Reference is made to the tender N° 02/G/ICB/2022-2023/RAC for supply, installation and commissioning of diesel generators and digital voltage regulator;

Following the request for clarifications raised by some of prospective Bidders, Rwanda Airports Company would like to provide the following clarifications for your consideration.

PLC Cabinet wiring

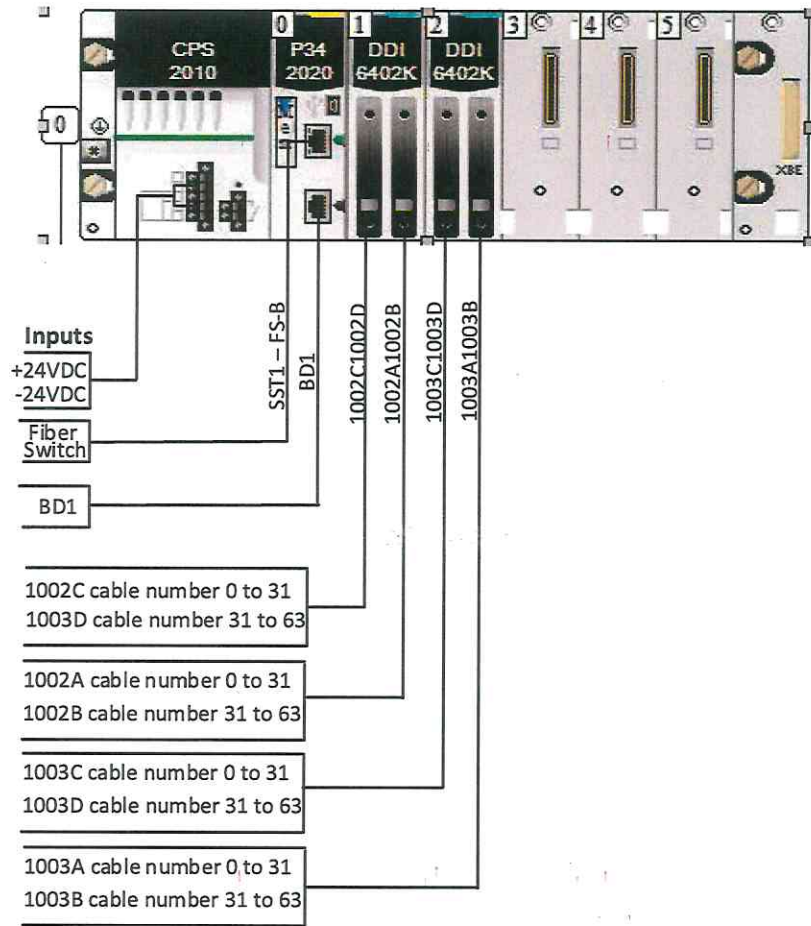
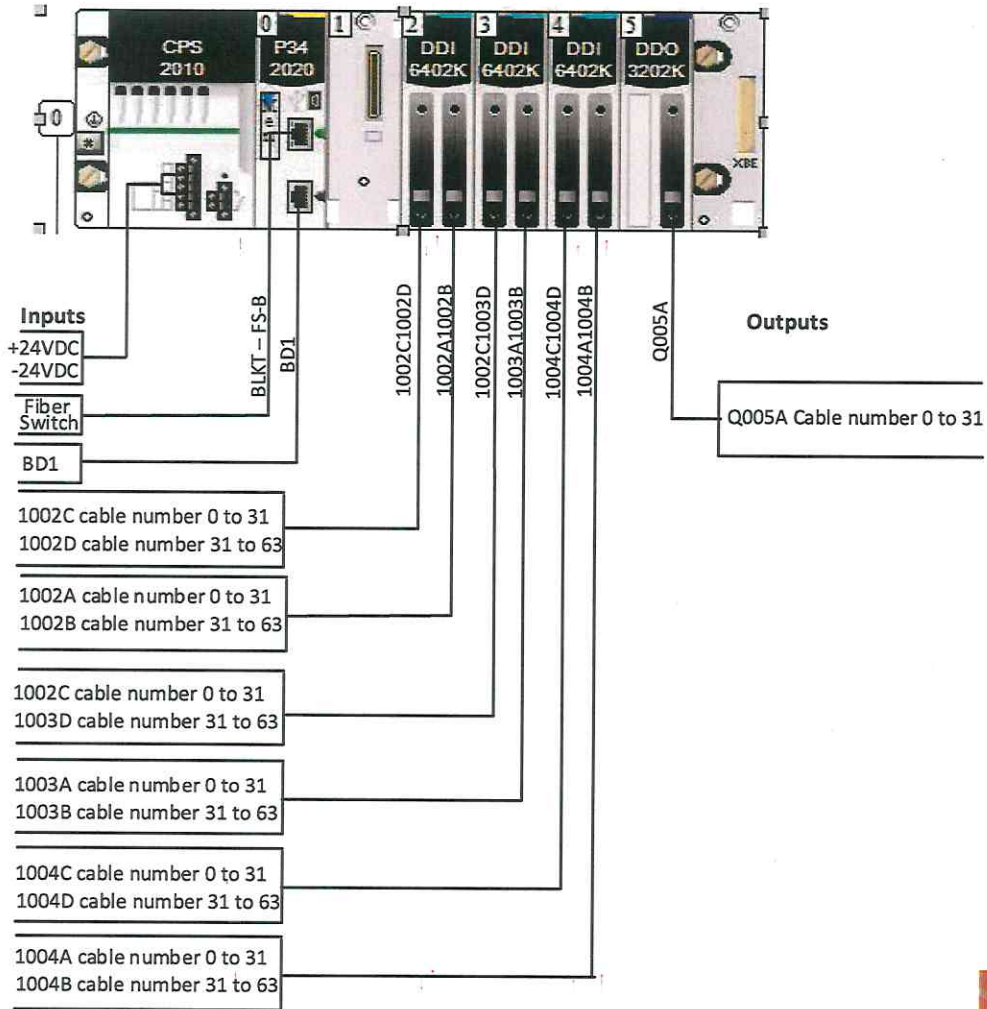
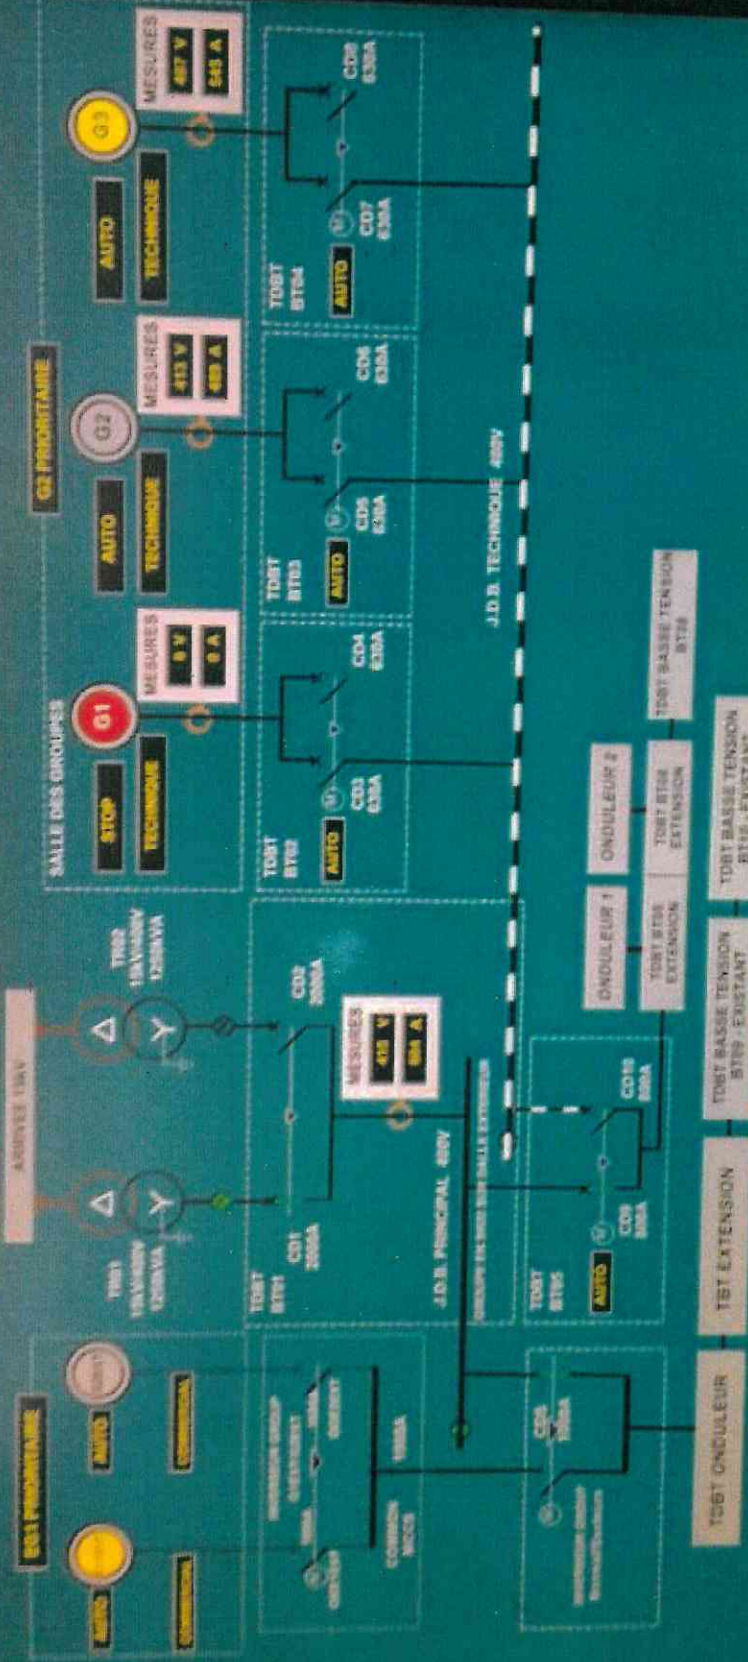
28.	Request Type RFD: Generator Control Panel drawing (Automatic control) (PLC panel)	Refer to the attached drawing called PLC wiring cabinet and Generator automatic control panel.

29.	Request Type RFD: Main PLC panel drawing	Refer to the attached drawing called PLC wiring cabinet
30.	Request Type RFD: SCADA Architecture drawing: This drawing should show the connection of all the equipment with the PLC and mode of communication	Refer to the attached drawing called

CONTRÔLE ÉLECTRIQUE - SALLE ÉNERGIE - DISTRIBUTION BASSE TENSION

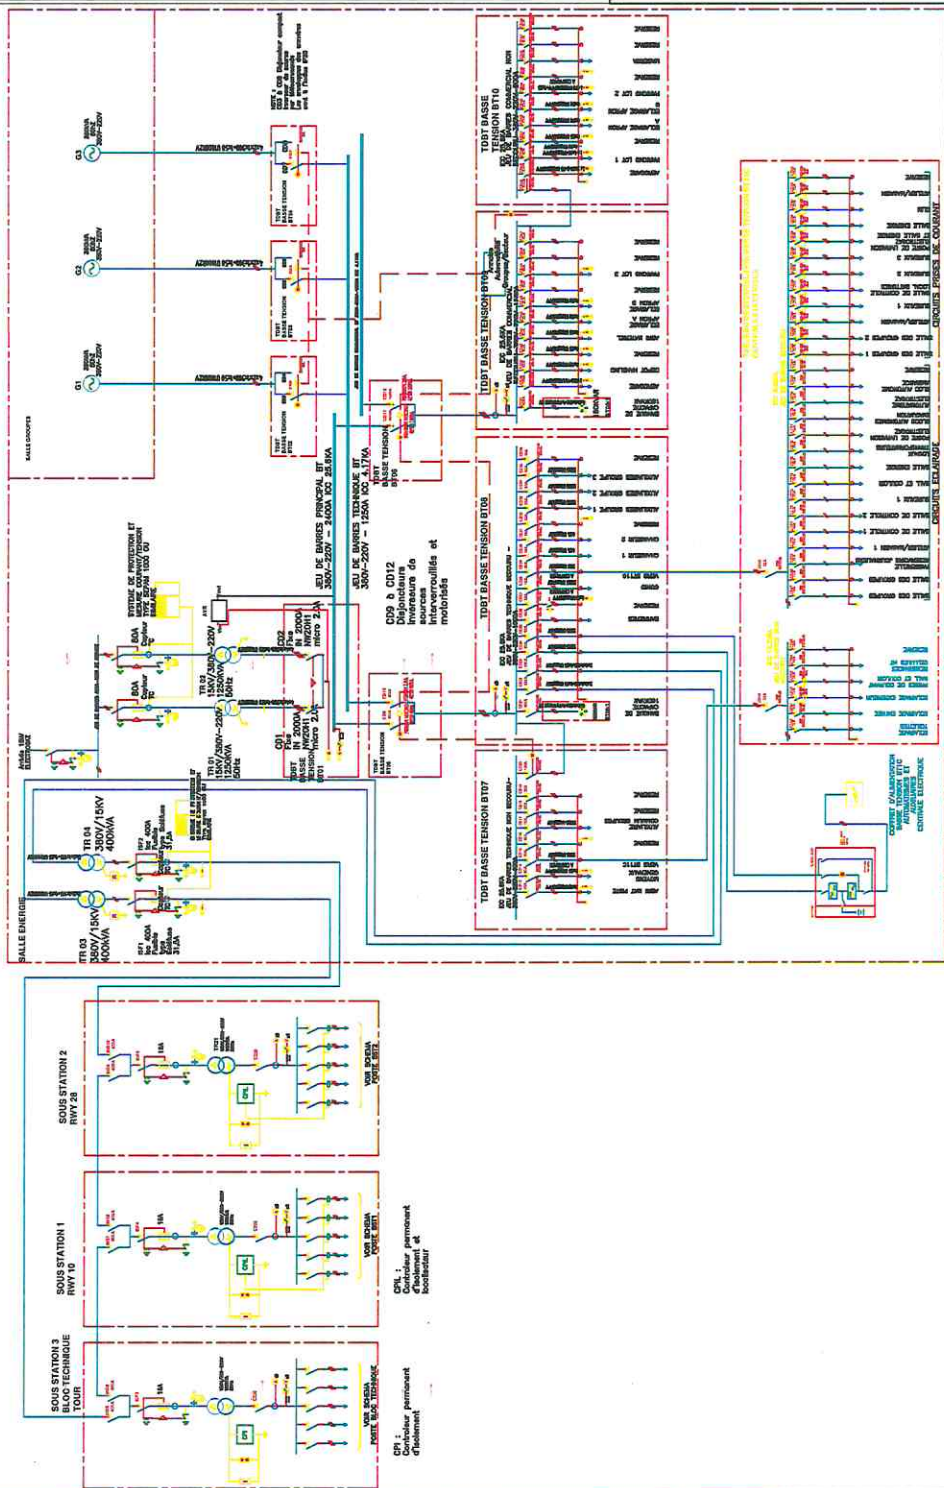
11.	All screenshots (SCADA HMI) to give a full picture of what is being monitored. From Dashboard to detail screens.	Refer to the attached screenshot, however the list of equipment to be monitored is this tender document (Page 64, 65, and 66)

CENTRALE ELECTRIQUE SD 001

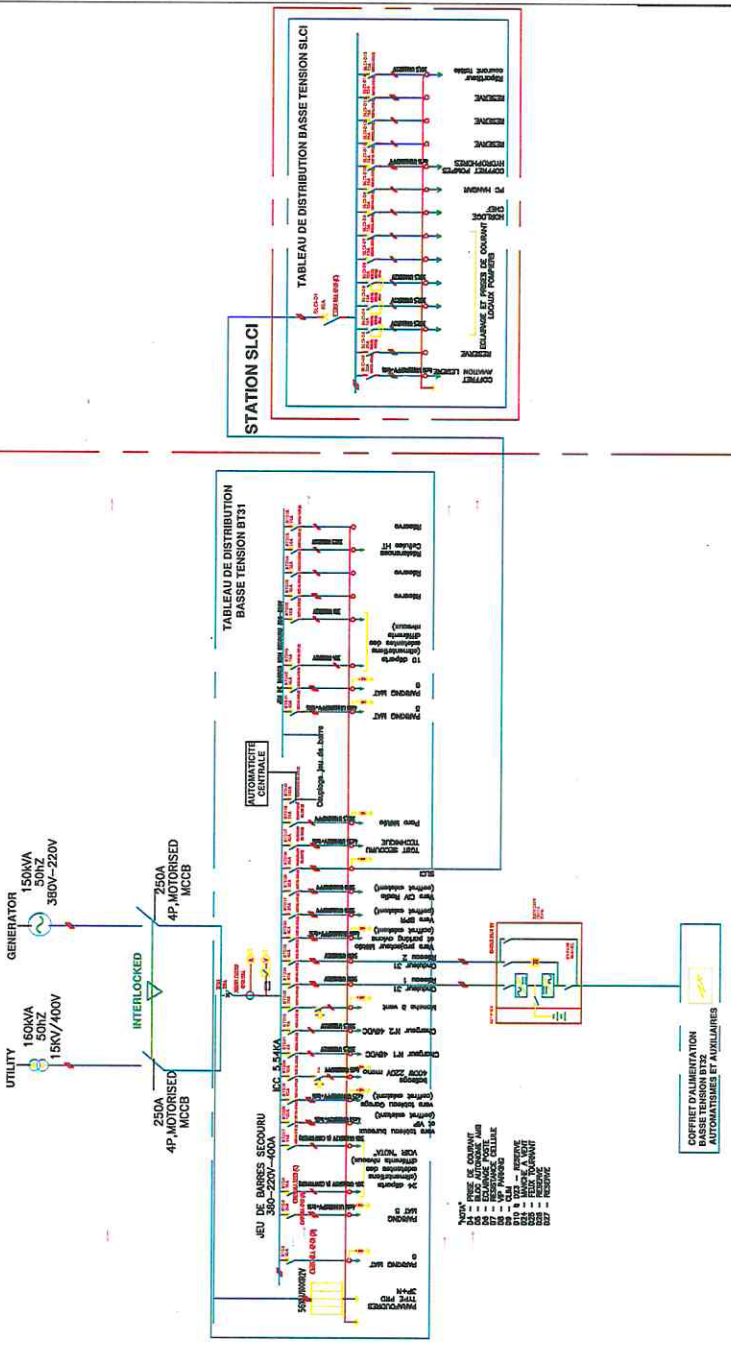
3.	Share the Schematic Drawings from the two Subject Generators to the Changeover panel.	Refer to the SD001 drawing on the attachment
4.	Share the Schematic and Shop Drawings of the LV Mains Board	Refer to the SD001 drawing on the attachment

26.	Request Type RFD: Main LV panel drawing	Please refer to SD 001
27.	Request Type RFD: Drawing for proposed change in the Main LV panel for new 800A C.B. in 630A C.B.	In the same drawing SD 001, an existing CB 3&4 of 630 shall be replaced by an upgraded to 800A, same to CD5&6.

33.	Request Type RFD: Proposed connection drawing of new AVRs with Main LV panel: Provide a drawing that outlines the proposed connection of the new Automatic Voltage Regulators (AVRs) with the Main LV panel.	Refer to SD001
34.	Request Type RFI: Redundancy for SCADA Server: Is redundancy for the SCADA server required? Please clarify.	Not required

PLC SYSTEM ARCHITECTURE SD003

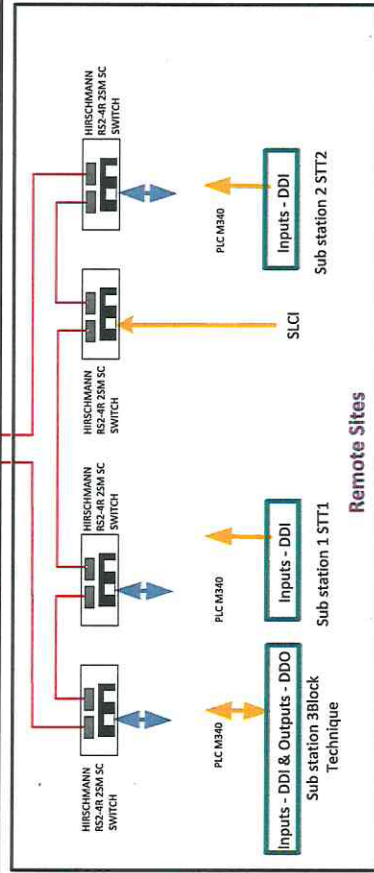
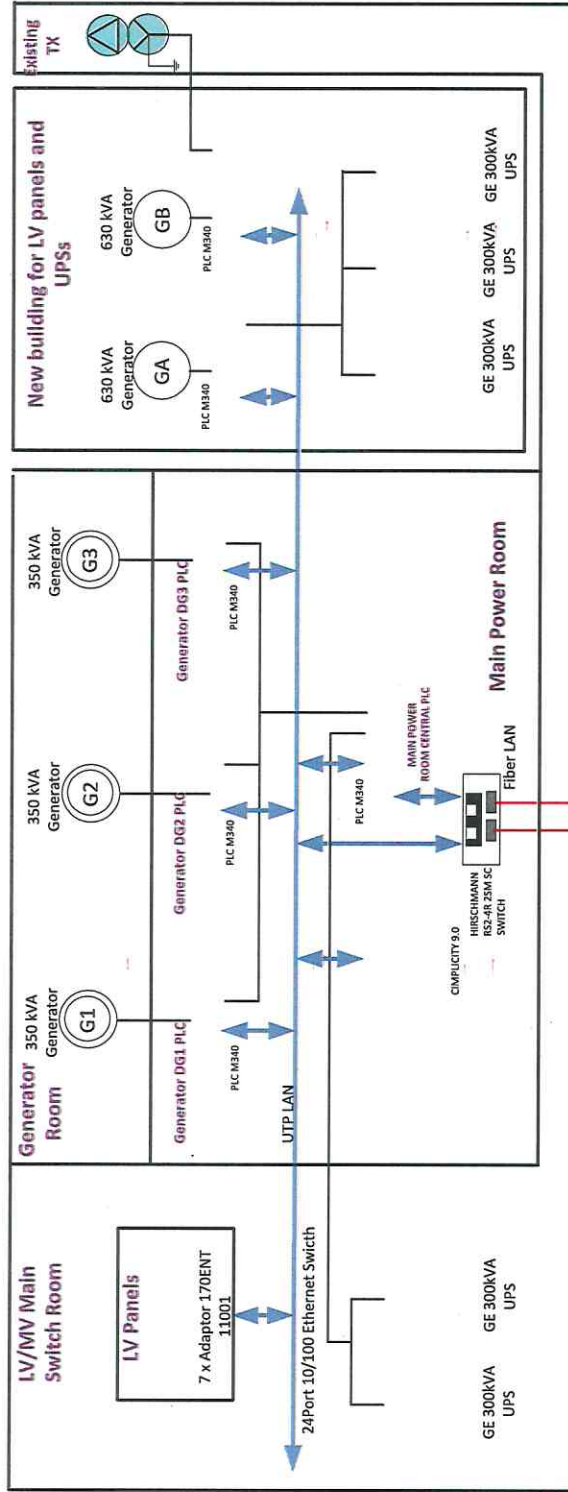
12.	How many Tags are currently being monitored (information points tracked from PLC by SCADA)?	Refer to the SD003 for Upgraded PLC M340 communication networks
